Granite School District
**SILVER HILLS ELEMENTARY
SECURITY REMODEL**
Project No. 2023.030.00

ADDENDUM NO. 1
January 23, 2024

The original specifications and drawings, dated October 31st, 2023 for the project referenced above are amended in the Addendum No. 1, dated January 23, 2024.

3 FINISH PLAN
AE110 1/8" = 1'-0"

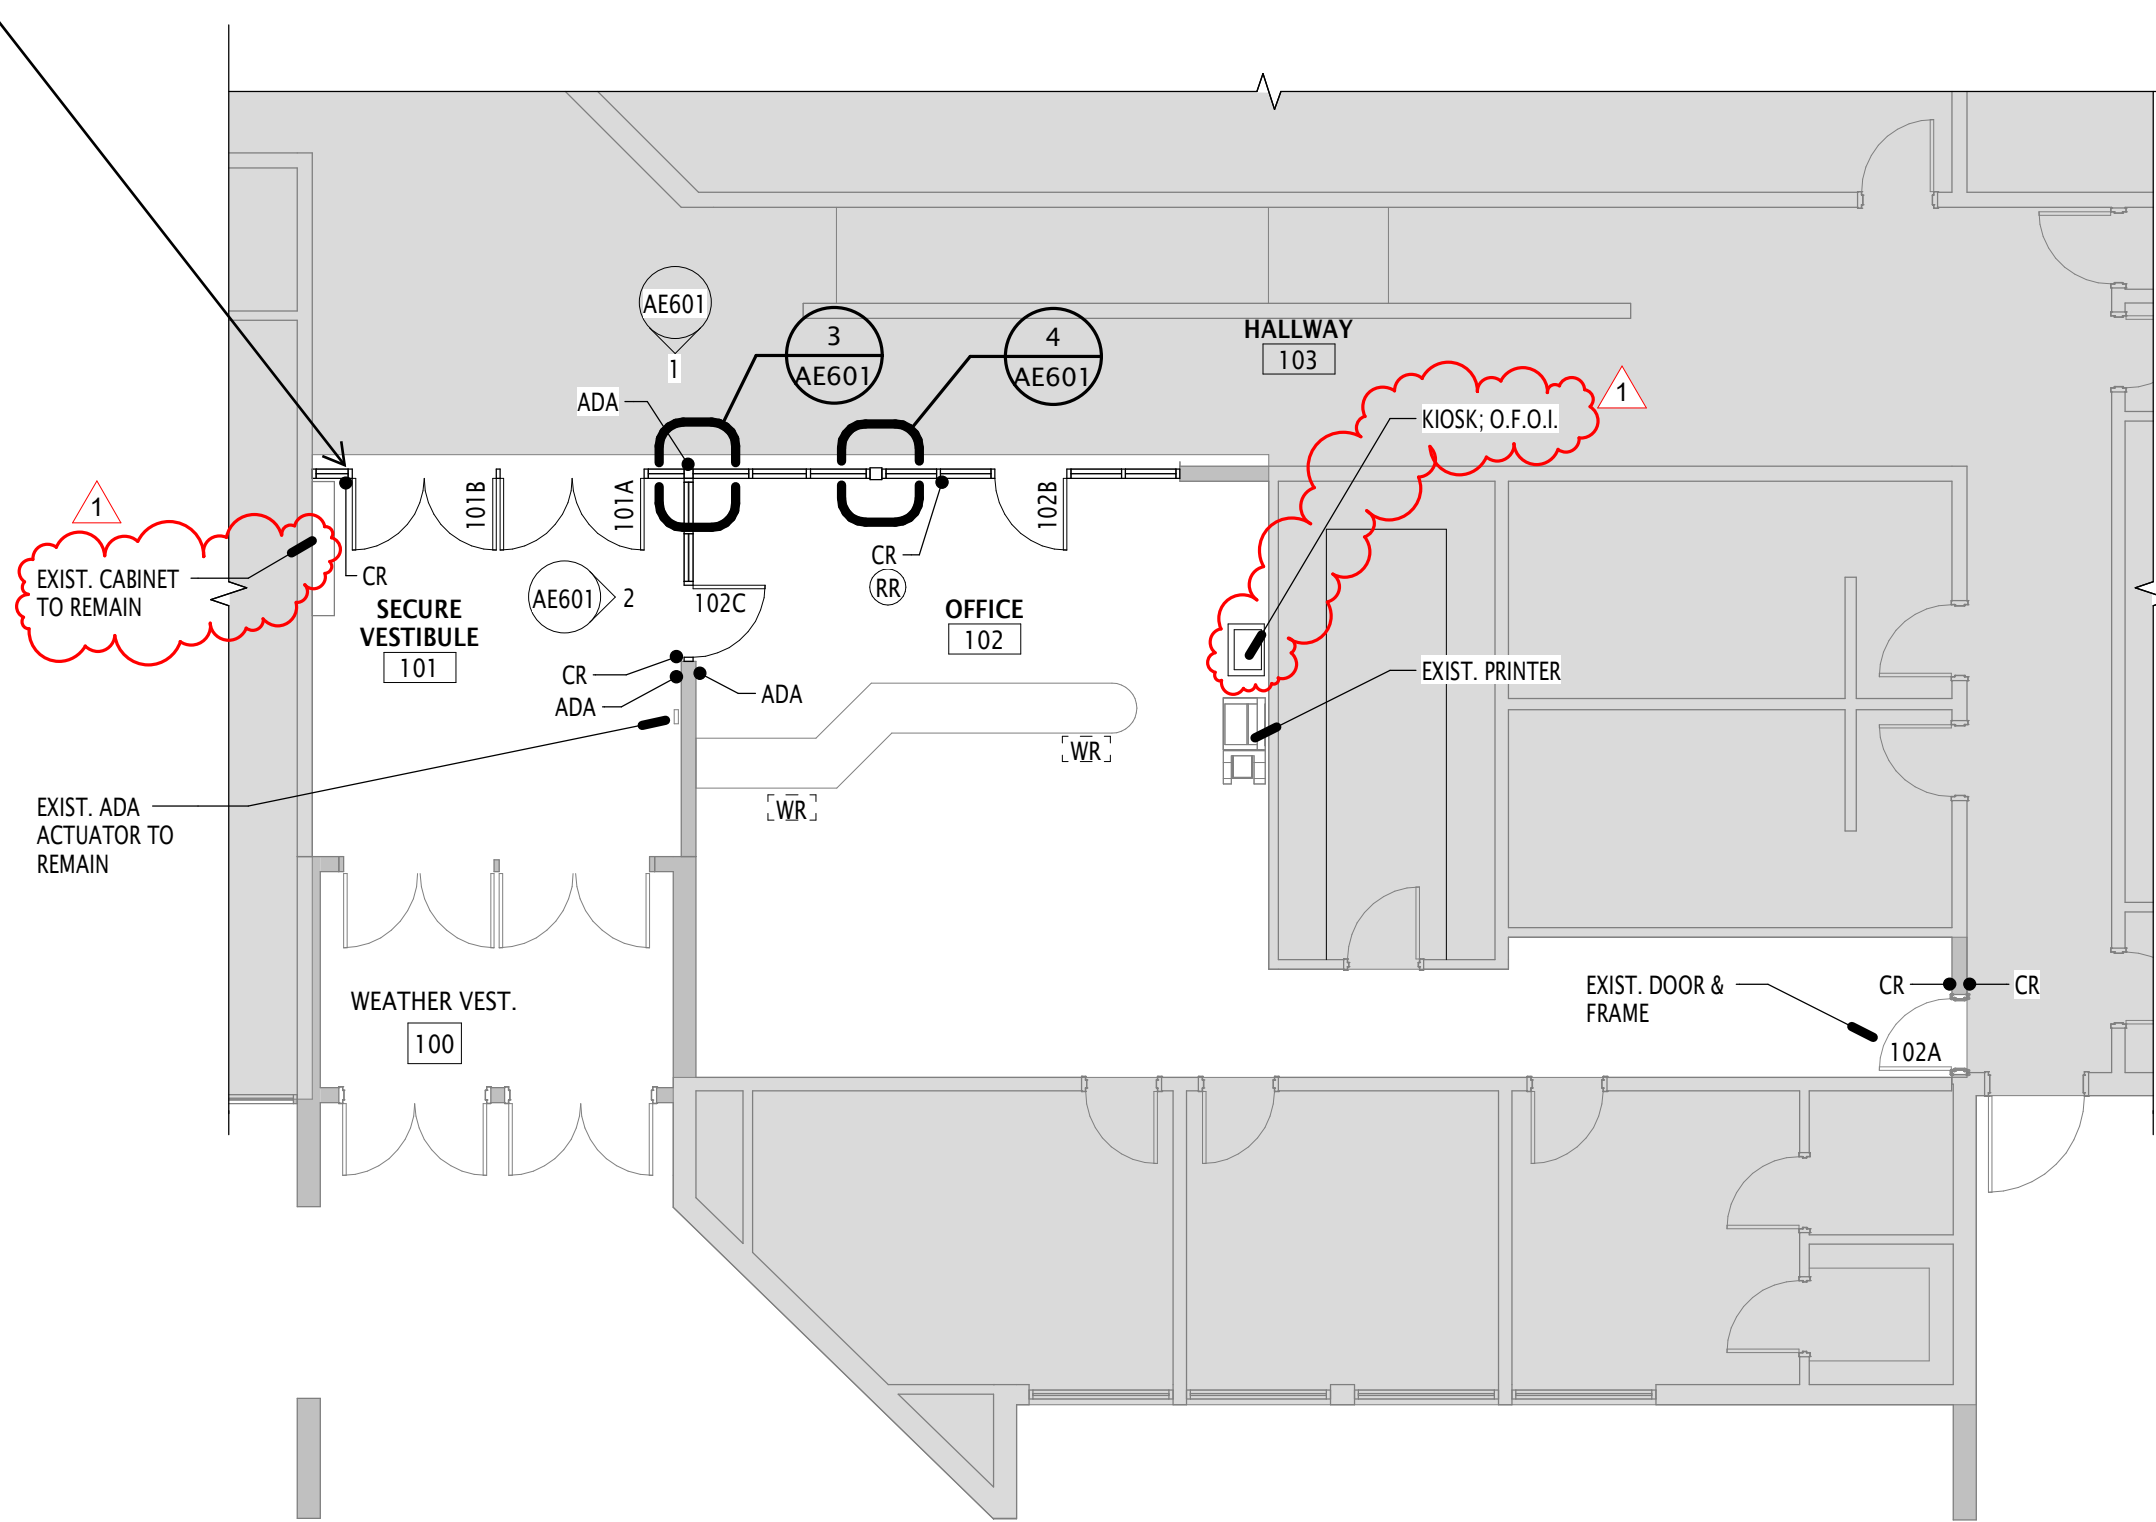
AD1-01 – Sheet AE110. Note clarification.
